**Flood Control Project Maintenance
Levee Inspections
Fall 2024 Levee Maintenance Deficiency Summary Report**

Sacramento River Basin

| RD0556 | Overall LMA Rating | Total LMA Miles | | | | | | |
|---|------------------------|------------------|--------------|-------------|-------------|---------|------------------------------|---------|
| Reclamation District No. 0556 Upper Andrus | U | 11.20 | | | | | | |

Reclamation District No. 0556 Upper Andrus

Photo 1 of 1 : FA_2024_RD0556_18_21_20241023_00096.jpg

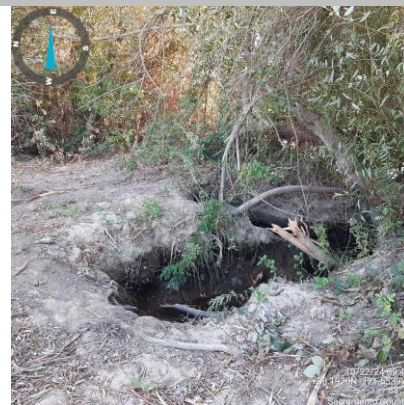
| Vegetation control revealed large collapsed portion of waterside bank. Erosion believed to be old beaver den that has collapsed and eroded away over time. Erosion is on the waterside berm, outside of the levee prism and will be monitored by the LMA to track erosion progress. | | | | | |

Photo 1 of 1 : FA_2024_RD0556_18_44_20241023_00100.jpg

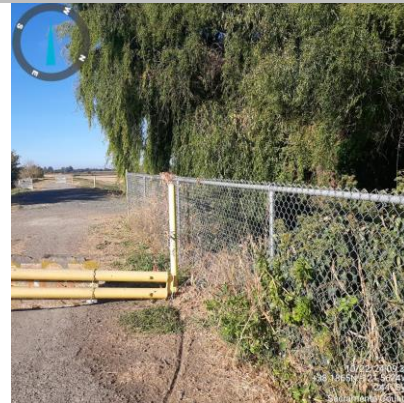
| V6 : Landscaping | | | | | |

Photo 1 of 1 : FA_2024_RD0556_19_35_20241106_00100.jpg

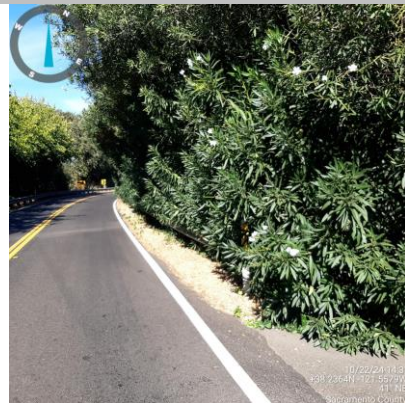
| Trim/thin oleanders to allow inspection and access to landside slope and toe. | | | | | |

Photo 3 of 3 : UCIP_FA_2024_76303_113531.jpg

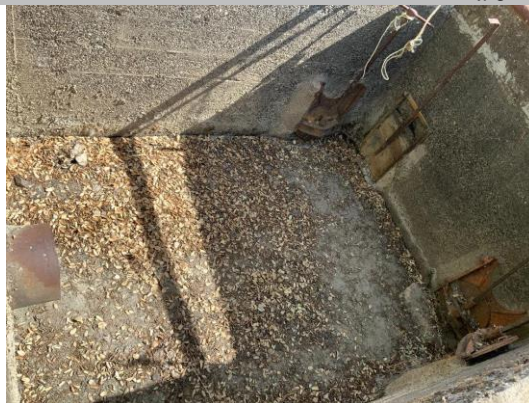
| DS_ID:20862 FS_ID:76303 EP_NO: N/A Repair Type: Urgent EVAL Issue: 3b, Flood Risk Crossing Status: Found UCIP Comments: 05/12/2022 Record updated from Non-Urgent to Urgent. Modification of sleeving the pipe, and gap in between pipe and sleeve, causes flood risk concern. The UCIP inspection was completed with GEI staff, A. Lao. (H. Dunn ? GEI)04/25/2013 9-inch steel pipe sleeved through 12-inch pipe. Needs to seal gap between two pipes. (P. Amatya - DWR) FIELD_STRUCT_DESC: 9-inch steel pipe sleeved through a 12-inch steel irrigation discharge pipe through the levee, 6 feet below the crown. Pump on a pile structure in the river. Steel walkway to the pump and wood steps on the waterside (WS) slope. Concrete spill box with two 8-inch openings. (Six 12-inch steel discharge pipes (pipe 6 of 6) authorized under Permit No. 1173, 1947 - Reclamation District No. 556). (12-inch pipe [HLM 3.06] authorized under Automatic Board Order (ABO) issued as Permit No. 11193, 1975 - Gertrude M. Reid). [Additional Reference(s): DWR Levee Log, year unknown (HLM 3.06), listed as 12-inch pipe. USACE Sacramento O&M Manual, Unit 103, June 1954, Revised 29 December 2016, (Station "J" 80+79), listed as 12-inch pipe. USACE As-Built Drawing No. 50-04-2277, March 1946, Sheet 3, Station 80+79 "J", listed as 12-inch pipe]. FS Date: 5/12/2022 12:09:29 PM | | | | | |

Photo 1 of 1 : FA_2024_RD0556_19_40_20241106_00102.jpg

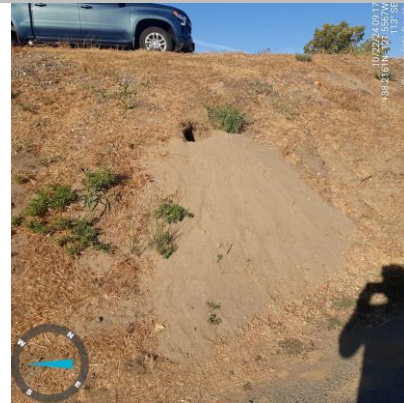
| A3 : No rodents visible, but rodent burrows visible; need to backfill and compact or grout burrows. | | | | | |

Photo 1 of 1 : FA_2024_RD0556_19_55_20241106_00104.jpg

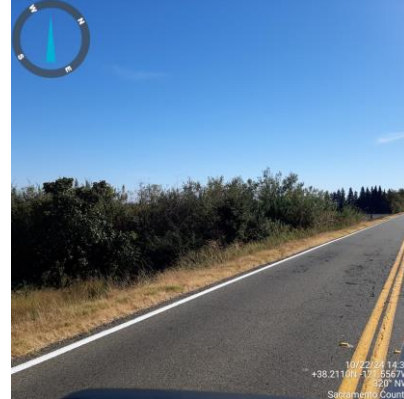
| T1 : Trim and thin trees to at least five feet above ground level to allow visibility of the ground and room to flood fight. | | | | | |

Photo 1 of 1 : FA_2024_RD0556_19_37_20241106_00106.jpg

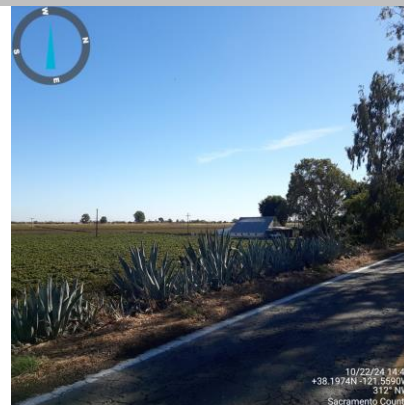
| Remove cactus, and century plants on the landside slope. | | | | | |
